**Re: Second Submission Review – Nick’s Convenience – Jackson Gap at Porteos – Site Plan and Plat Application**  
Number: **DA-1903-35**  
Case Numbers: **2023-6040-00, 2023-3038-00**

### *Second Submission Review*

# SITE PLAN - NICK'S CONVENIENCE

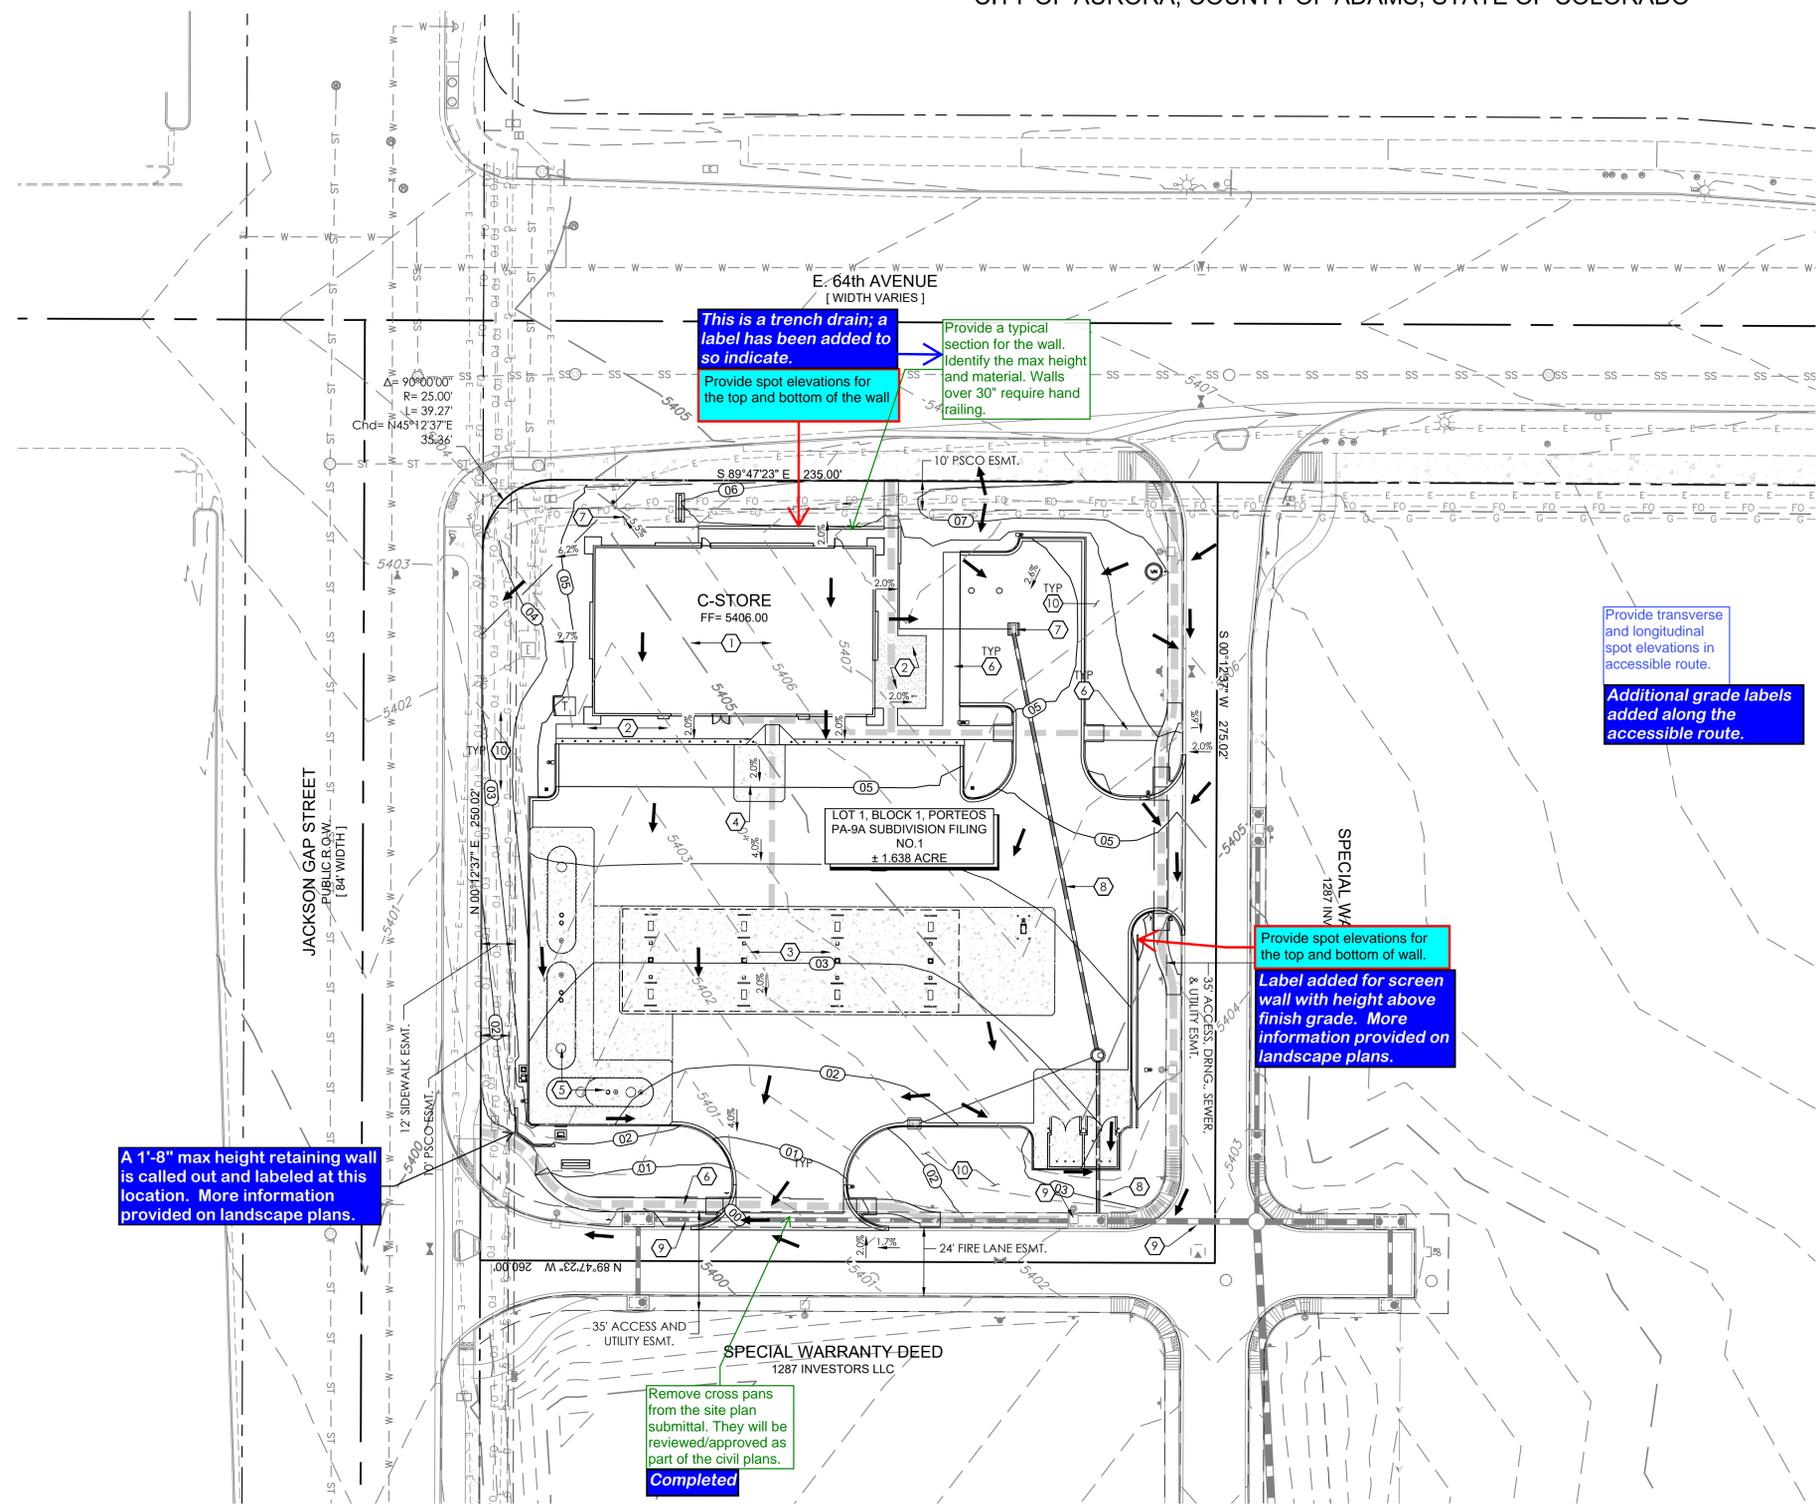
This is a trench drain; a label has been added to so indicate.  
 Provide spot elevations for the top and bottom of the wall.  
 Provide a typical section for the wall. Identify the max height and material. Walls over 30" require hand railing.

Provide transverse and longitudinal spot elevations in accessible route.  
 Additional grade labels added along the accessible route.

Provide spot elevations for the top and bottom of wall.  
 Label added for screen wall with height above finish grade. More information provided on landscape plans.

Remove cross pans from the site plan submittal. They will be reviewed/approved as part of the civil plans.  
 Completed

A 1'-8" max height retaining wall is called out and labeled at this location. More information provided on landscape plans.

LANDSCAPE PLANTING PLAN, NICK'S CONVENIENCE, xxxxxx E. 64th AVENUE, AURORA, COLORADO

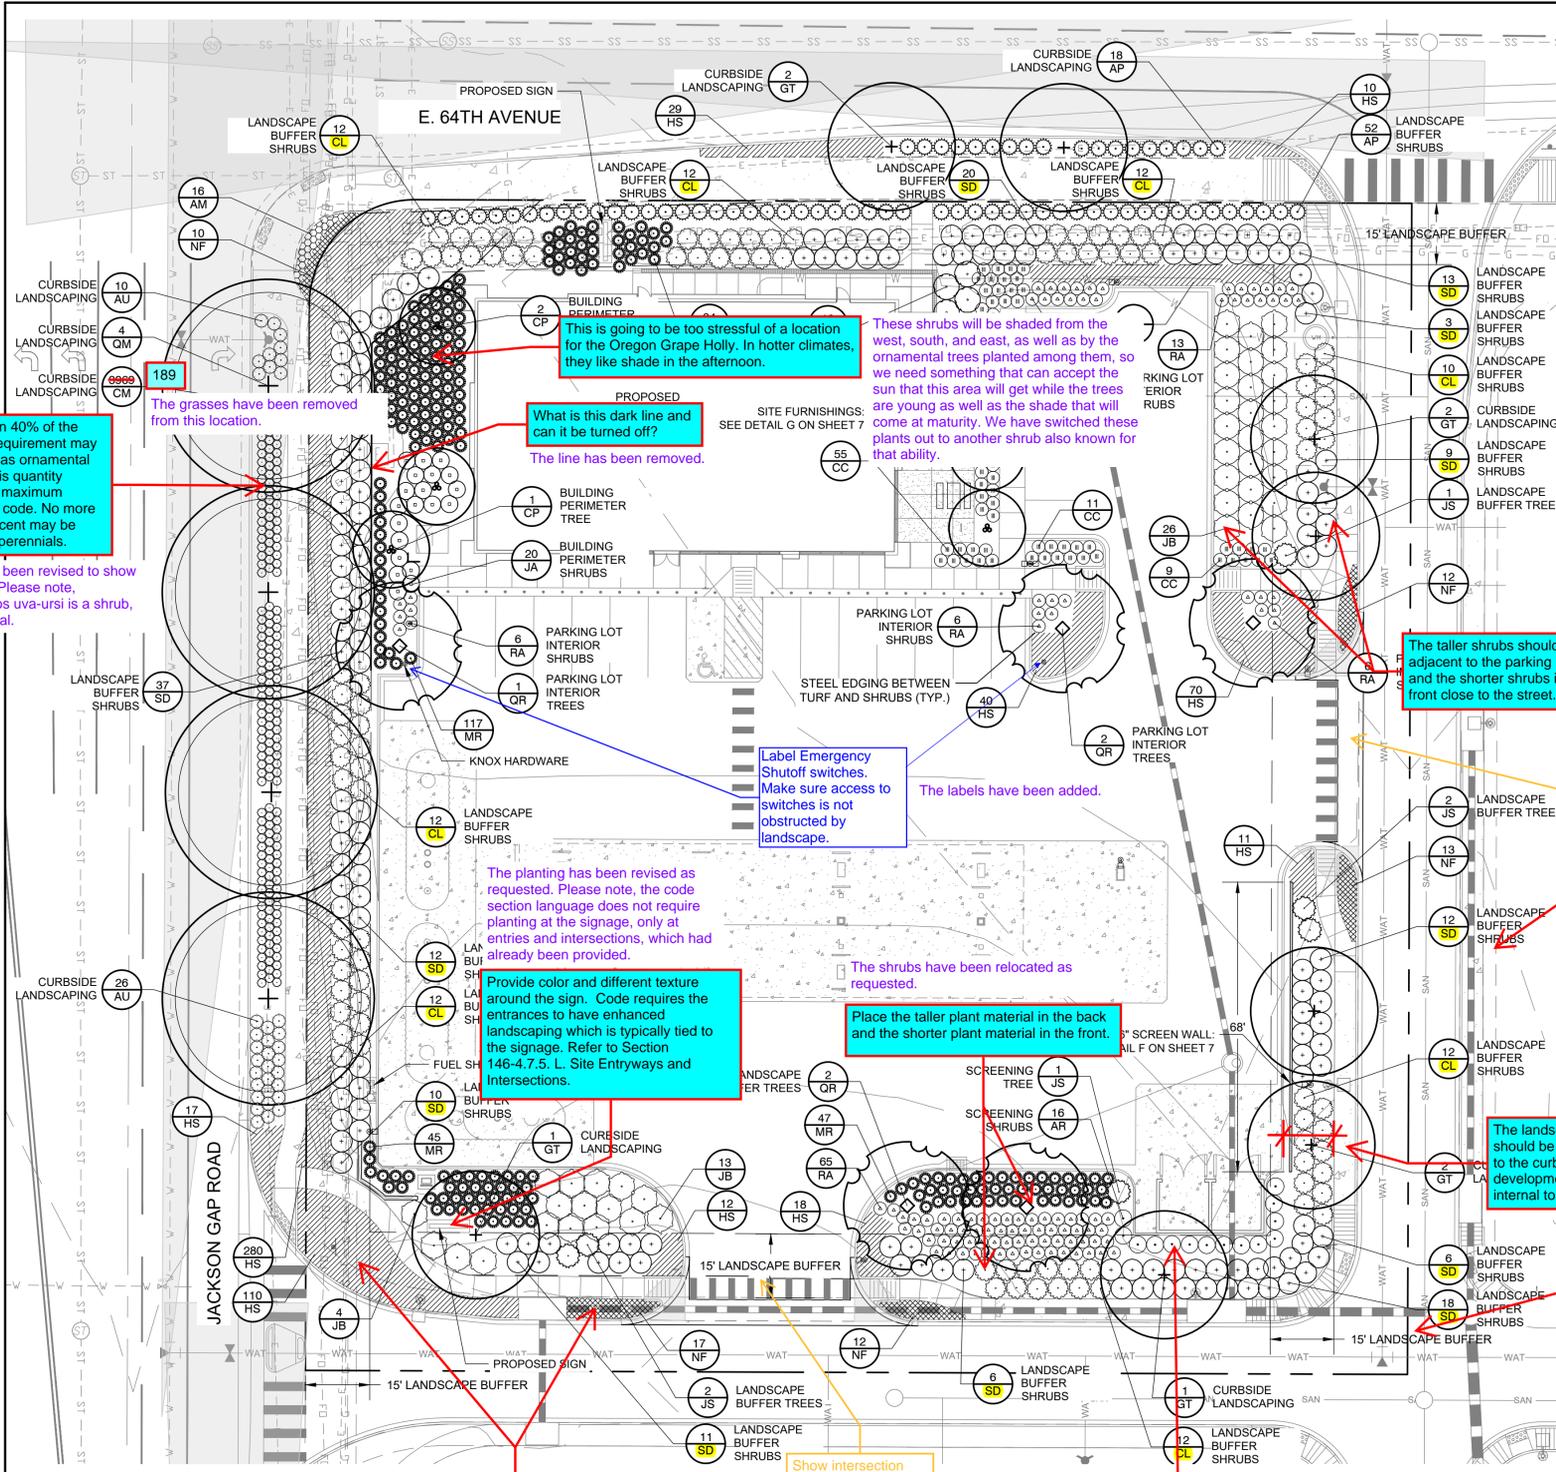
There is too much of the same shrub being used on this landscape plan. Select a different shrub for some of these locations. There is a lot of Broom and Snowberry being used.

These notes appear here and on Sheet 5. Only one set is necessary.

Show intersection sight triangles

The curbside landscape cannot be all perennials and ornamental grasses. Add this area to the landscape tables.

Provide a taller plant along here to supplement the concrete masonry unit wall that is proposed. Preferably evergreen plantings.

Add the five required landscape notes as found in The Landscape Reference Manual found on line.

The notes were added as requested in the last round of comments. They have now been removed from this sheet.

An additional shrub species has been added to the list and took the place of multiple clusters of Symphoricarpos and Cytisus.

The plan has been revised to show only shrubs. Please note, Arctostaphylos uva-ursi is a shrub, not a perennial.

These shrubs will be shaded from the west, south, and east, as well as by the ornamental trees planted among them, so we need something that can accept the sun that this area will get while the trees are young as well as the shade that will come at maturity...

The sight triangles have been added as requested.

The buffer line has been moved as requested. Please note, this comment is requiring a different approach from that required by the code, which reads:

Evergreens have been added as requested.

5 ELEVATION - SOUTH  
1/4" = 1'-0"

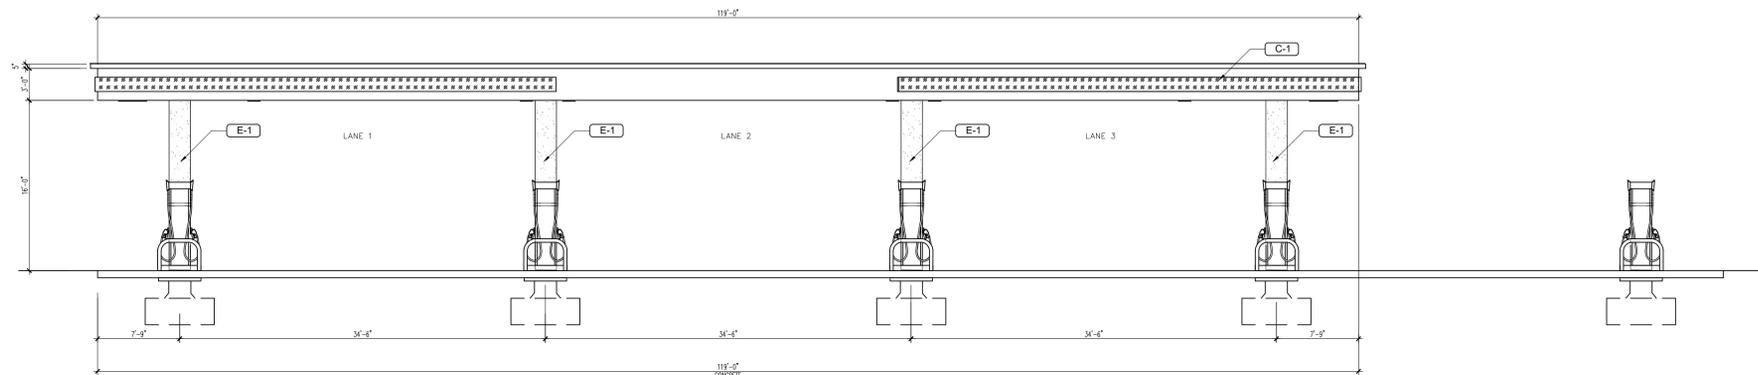
A roof form or height variation is required for roofs, including canopy roofs. Variation is required every 60 ft, so this will only be needed on the front and rear elevations. The added cornice, while appreciated, does not vary along the length of the canopy.

The canopy has been revised to include a 2 foot high raised portion in the center of the canopy

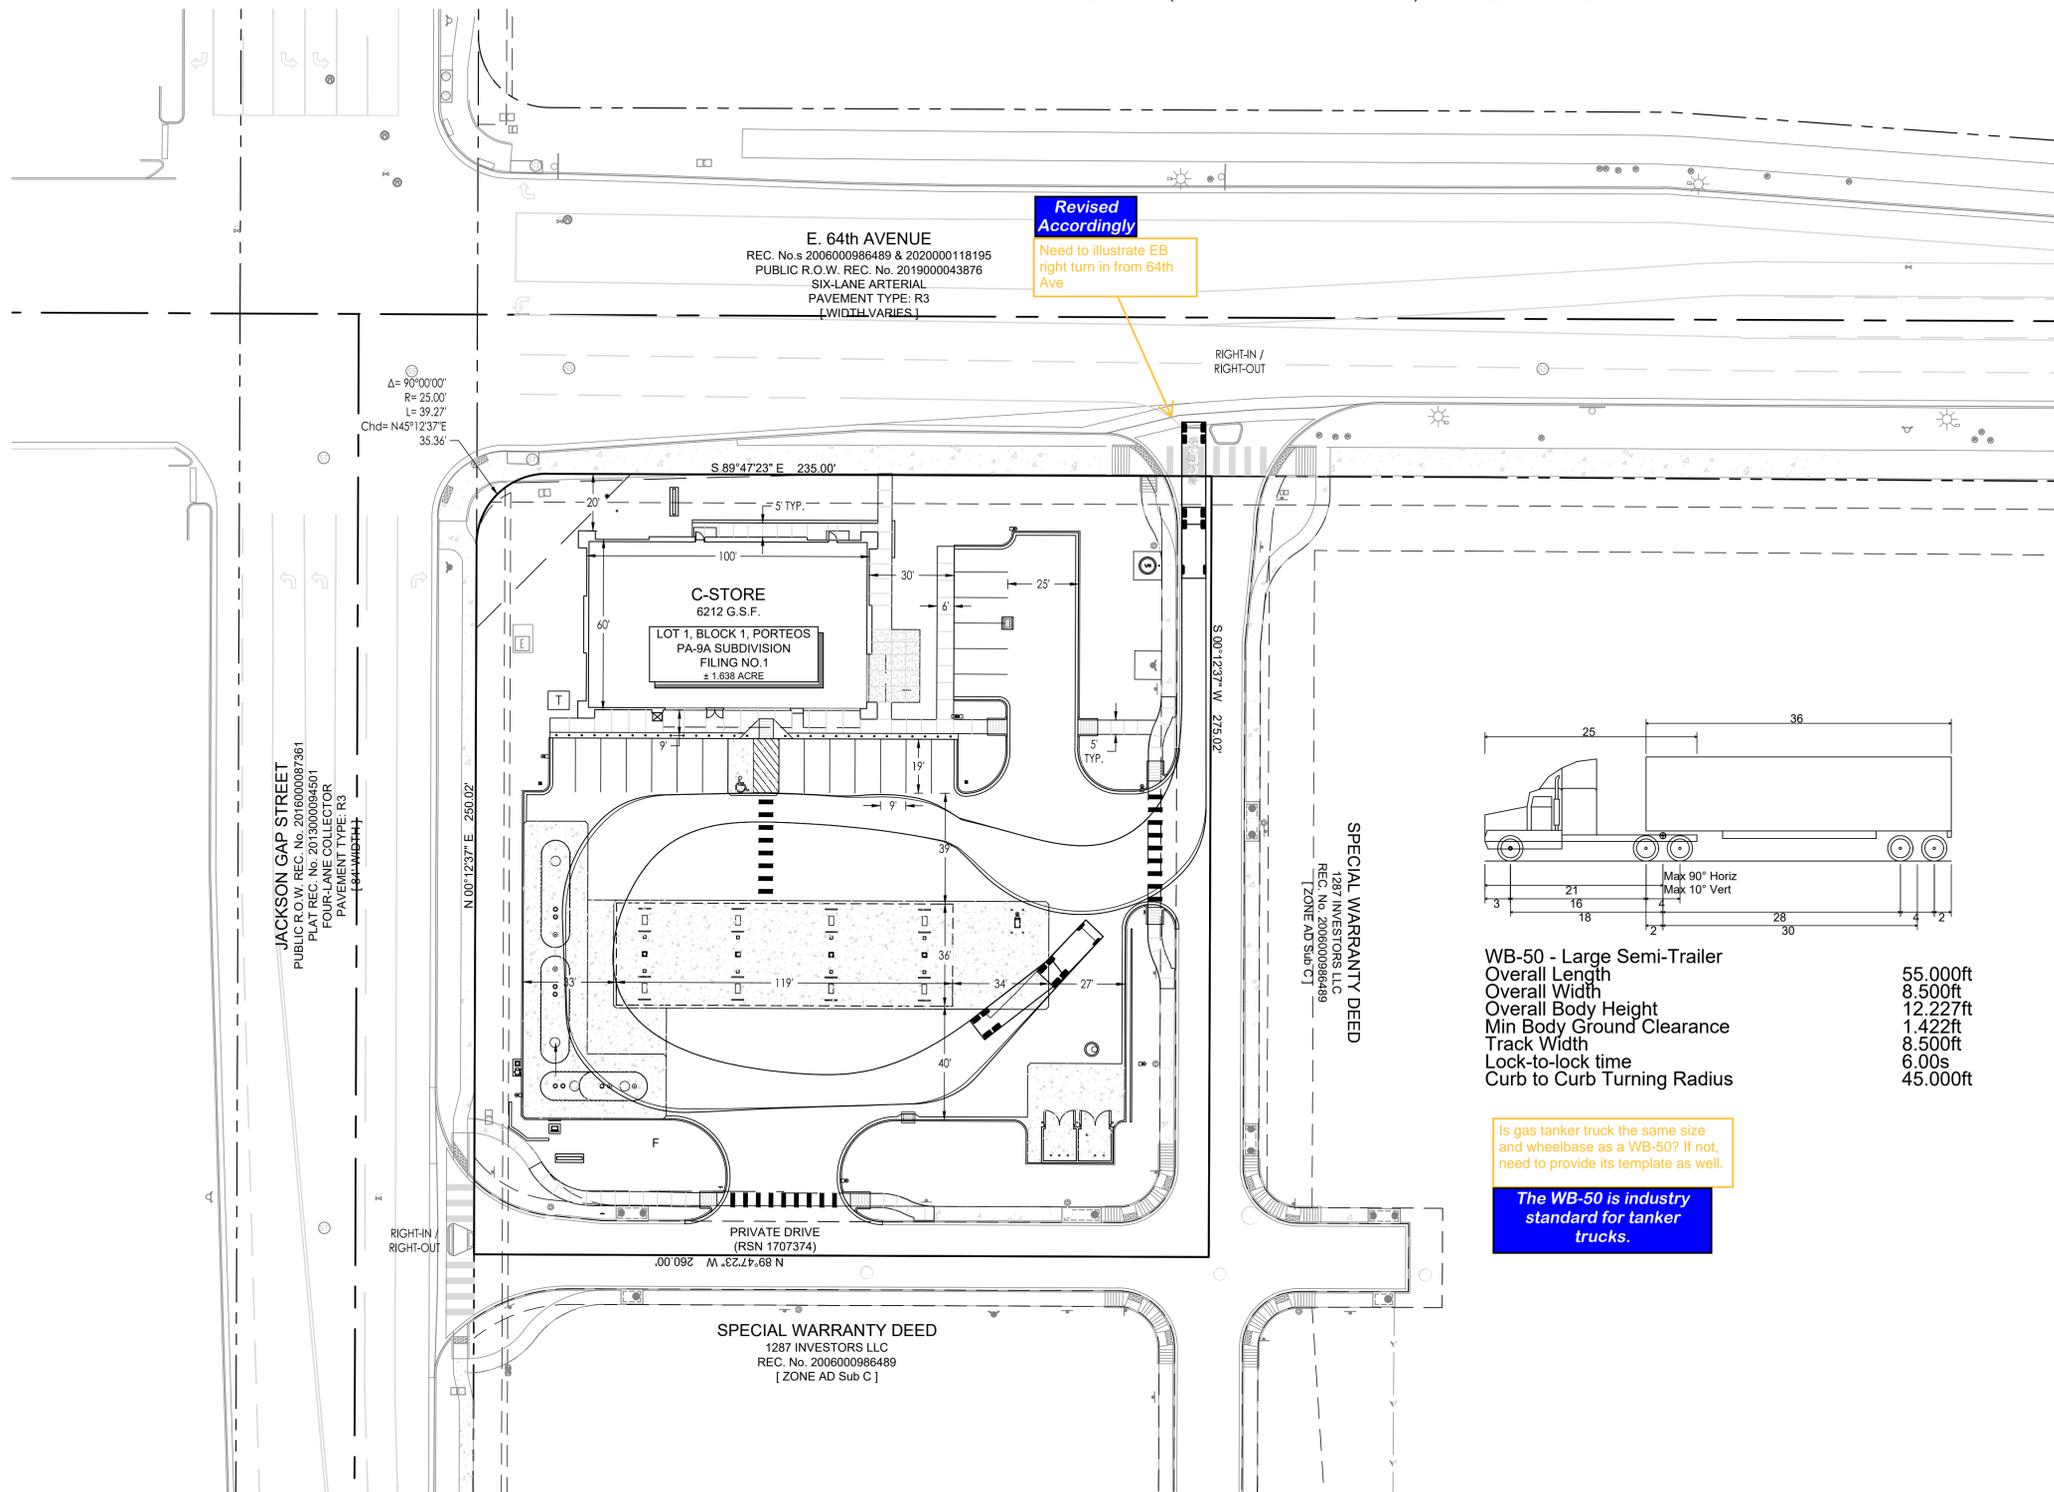
Is gas tanker truck the same size and wheelbase as a WB-50? If not, need to provide its template as well.
